35/36-97B 5707 Surrey Street, Chevy Ch.
(Somerset Historic District)

HISTORIC PRESERVATION COMMISSION STAFF REPORT

Address: 5707 Surrey Street

PROPOSAL: Rear addition, front overhang, window replacement, tree removal.

BALGE RES. 5107 SURREY ST.
ROBERT CURTIS ARCHITECTS
4-21-97

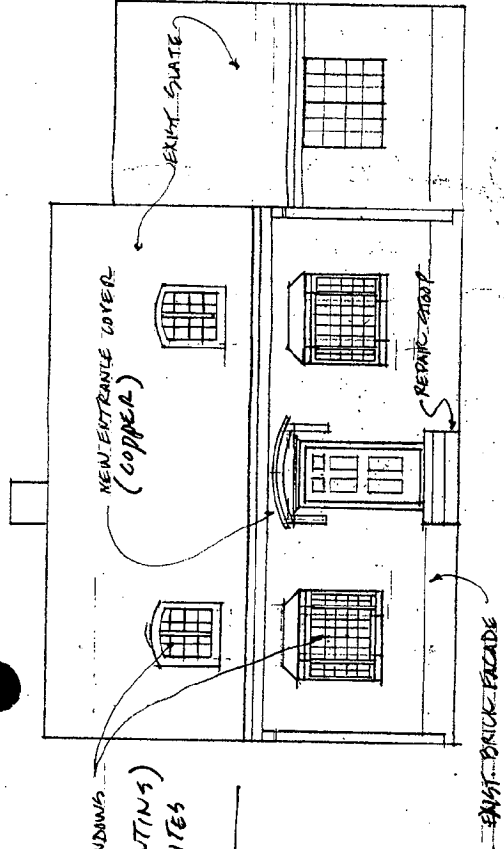
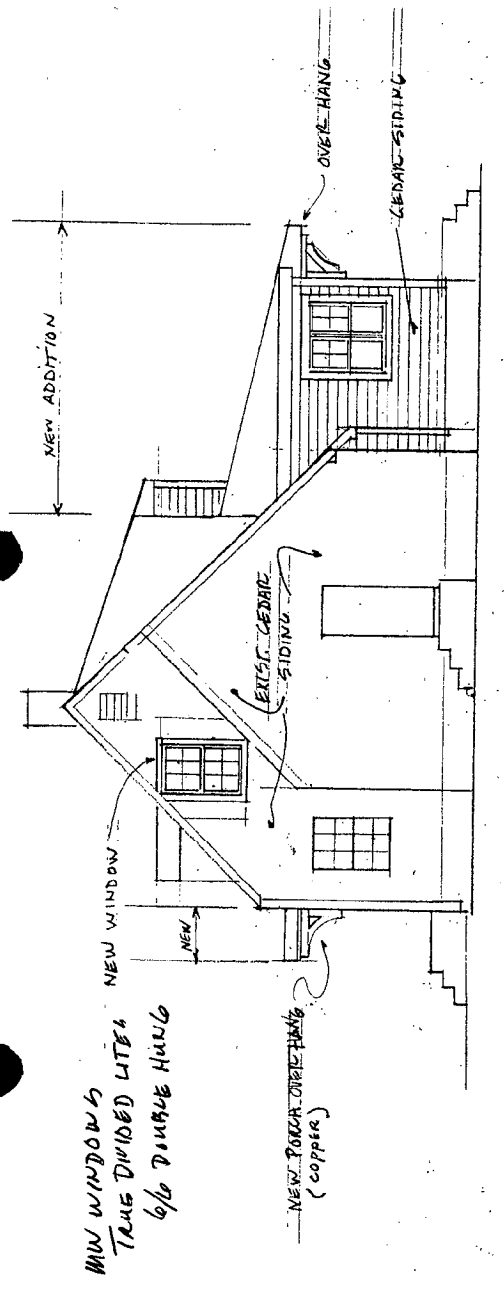
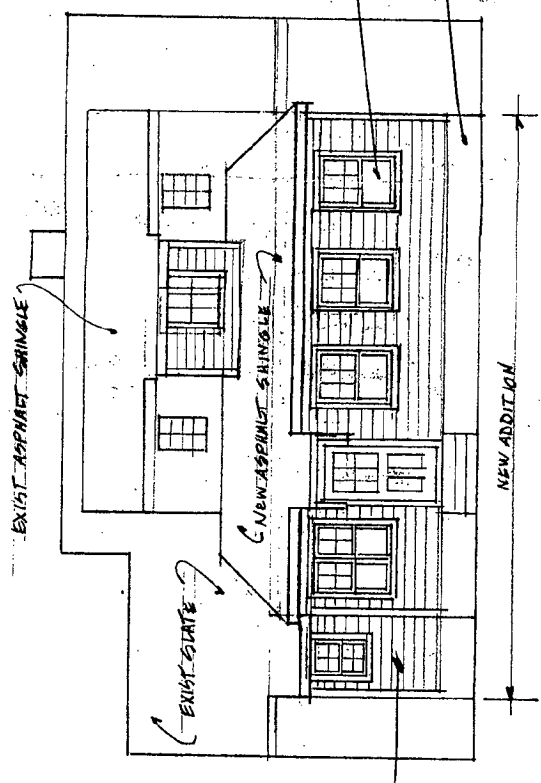
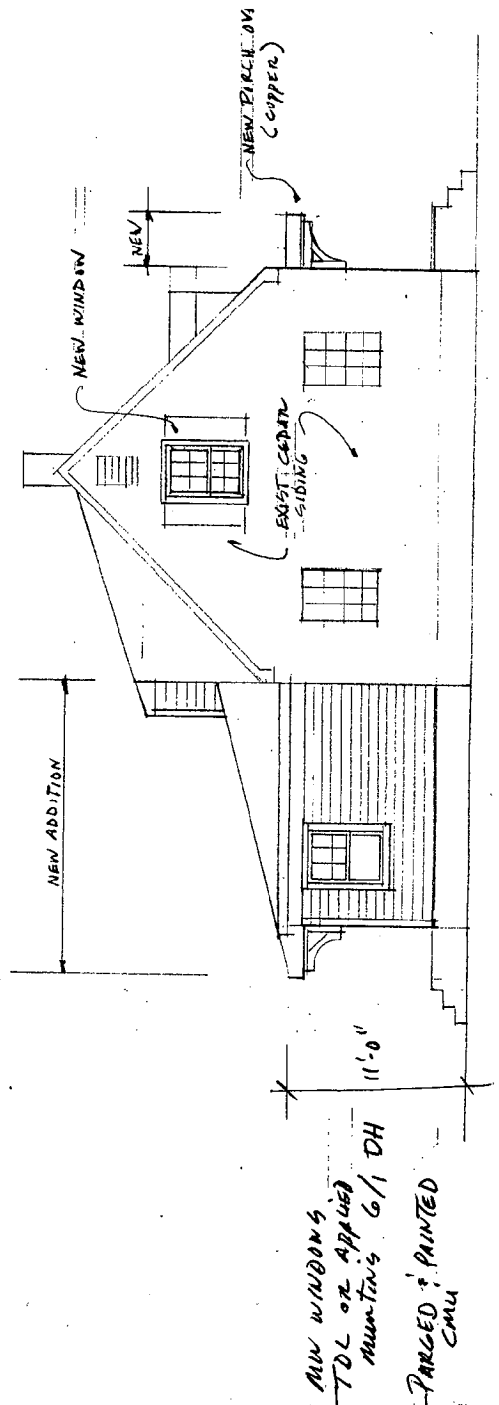
Tree Removal

Siding to match

Window replacement

Main roof is slate +
new roof = asphalt

existing former =
asphalt
already.

NEW WINDOWS
(APPLIED MOUNTING)
OR TRANE DIVIDED LITES

CEDAR SIDING (PAINTED)

TREE REMOVAL

- 1 MAPLE at REAR
- 2 MAPLES ALONG NORTH BOUNDARY ?
